ADDRESSEES	: ABC Customer Care and Parts Source Owners and operators of coaches listed under “Application”
VEHICLE TYPE	: CX45, TX40, TX45, TDX25US
CONFIGURATION GROUP	: 02.46 Engine – Accessory drive systems
BULLETIN TYPE	: Field Change Program
DATE	: March 16th, 2018
SUBJECT	: To change fixing screws of fan-drive idler pulley bracket
TERMS & CONDITIONS	: Refer to the warranty section further in this Bulletin.

This service bulletin gives step-by-step instructions to change the fan-drive idler pulley bracket grade 8.8 fixing screws.

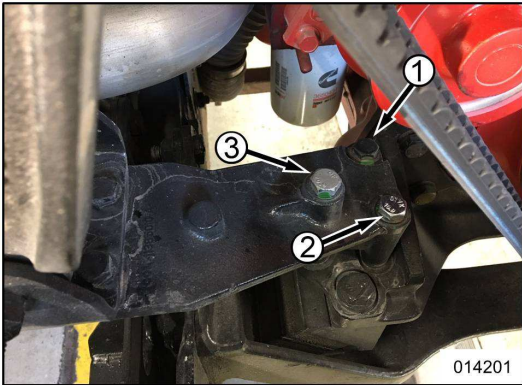
Issues have been reported about broken fan-drive idler pulley bracket grade 8.8 fixing screws. Investigation has shown that the grade 8.8 fixing screws, securing the idler arm to the engine crossmember, could break under heavy operating conditions.

To address this issue Van Hool is conducting a Field Change Program to change the grade 8.8 screws by grade 10.9 screws.

Step	Action															
1	Open the rear engine compartment door.															
2	Release the tension from the fan drive belts. Follow the procedure as described in chapter 2.46 of the maintenance manual.															
3	<p>Replace the three grade 8.8 screws installed by the grade 10.9 screws of the kit. Replace them one by one to be sure that the idler pulley arm remains positioned.</p> <ul style="list-style-type: none"> • Apply locking adhesive Loctite 270 or equivalent to the thread of the screws. • Tighten the grade 10.9 screws with a torque of 73 ± 10 ft.lbf (100 ± 15 Nm).

<table><tr> <th colspan="3" style="background-color: #cccccc;">Location of fixing screws according to length</th> </tr><tr> <th style="width: 20%;">Nr. in figure 2</th> <th style="width: 40%;">Kit 1</th> <th style="width: 40%;">Kit 2</th> </tr><tr> <td>1</td> <td>3.2 inch (80 mm)</td> <td>3.5 inch (90 mm)</td> </tr><tr> <td>2</td> <td>3.5 inch (90 mm)</td> <td>3.5 inch (90 mm)</td> </tr><tr> <td>3</td> <td>4.3 inch (110 mm)</td> <td>4.3 inch (110 mm)</td> </tr></table>
